Office Action Summary	Application No. 10/583,974	Applicant(s) ANDO ET AL.
	Examiner DANIEL A. BERNSTEIN	Art Unit 3743

DETAILED ACTION

2. Claims 1, 3 and 8 rejected under 35 U.S.C. 103(a) as being unpatentable over JP 2004-162936 A to Hara in view of US 4,426,923 to Ohata and US 2004/0216732 to McFadden.

F I G. 2

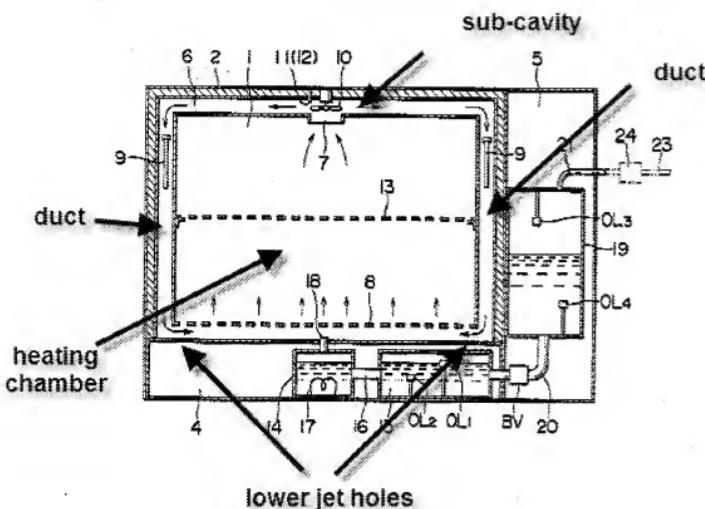
Ohata discloses a lower jet hole on each side wall of the heating chamber where the side jet hole jets out steam in a lateral direction of the heating chamber (see annotated Fig. 2 of Ohata below).

Ohata teaches a duct connecting between a sub-cavity and a side jet hole (see annotated Fig. 2 below).

Ohata teaches steam guided from a sub-cavity located in the ceiling of a heating chamber in which the steam is directed to a side jet hole on each side of the heating chamber so that the steam can impinge upon the food product from below (see annotated Fig. 2 below).

In regards to claim 3, Hara in view of Ohata and McFadden discloses the steam cooking apparatus of claim 1, wherein the side jet hole (lower jet holes, see annotated Fig. 2, Ohata) is so positioned and/or directed that, the steam jetted out from each side meets under the food (steam is directed from the sub-cavity through side ducts and enters through the lower jet holes meeting below and impinging on the food product from below).
